**HISTORIC PRESERVATION REVIEW BOARD
STAFF REPORT AND RECOMMENDATION**

Landmark/District:	Mount Vernon Triangle Historic District	<input checked="" type="checkbox"/> Agenda
Address:	444-446 K Street NW	<input type="checkbox"/> Consent
		<input checked="" type="checkbox"/> Concept
Meeting Date:	October 25, 2018	<input checked="" type="checkbox"/> Alteration
Case Number:	18-616	<input checked="" type="checkbox"/> New Construction
		<input type="checkbox"/> Demolition
		<input type="checkbox"/> Subdivision

Studio Crowley Hall, architects and agent for property owner Han Jan, seeks conceptual design review of a six-story addition at the rear of two two-story rowhouses built in the late 1800s.

September 2016 – Proposed 1st Floor

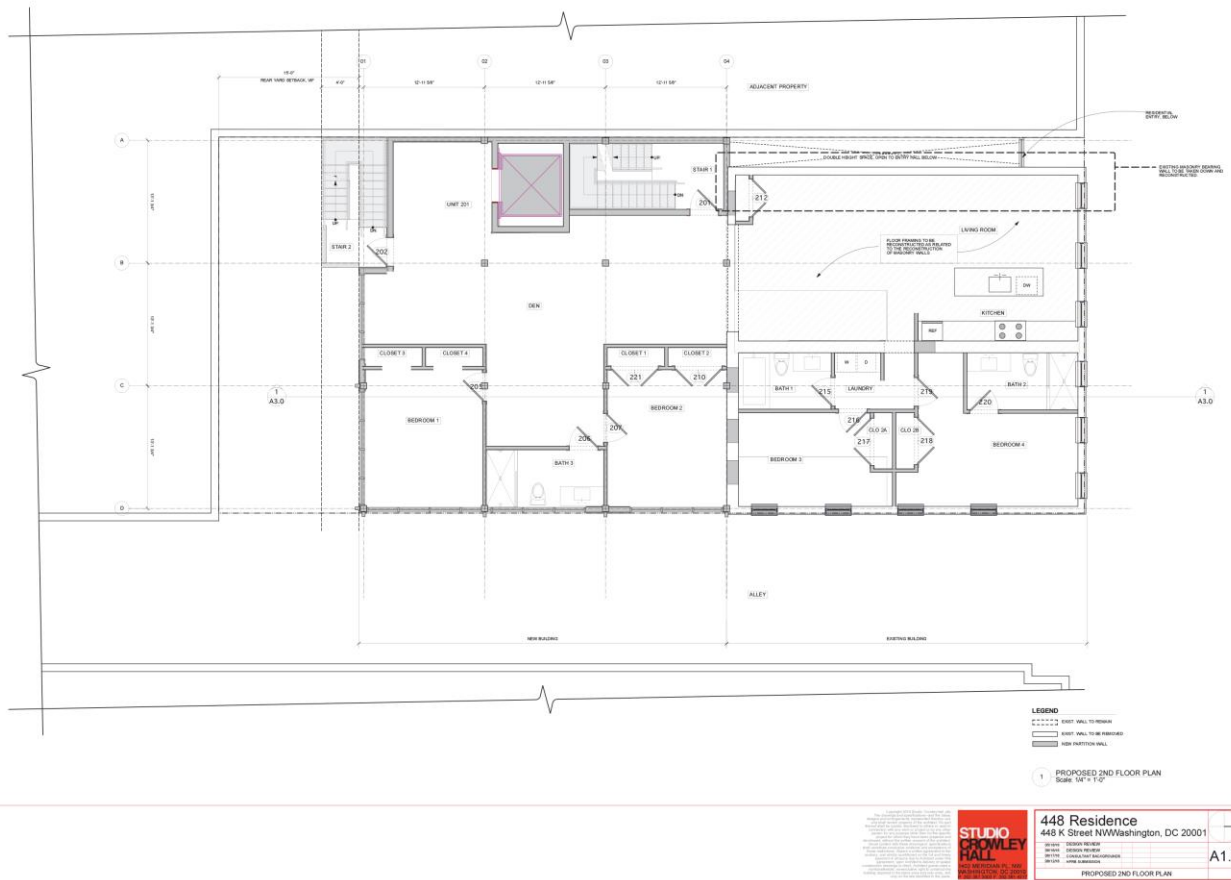
The project design before the Board today is similar but is now a six-story addition at the rear of the historic buildings with a revised interior plan on all levels. The architectural metal louver screen design would wrap the front and side elevations, similar to the previous submission. The first floor will be retail with a ground floor entrance at 444 K, and the entrance to the residential area will be located in a slot between 446 and 450 K Street – however, it is unclear if this space is wide enough to meet code requirements.
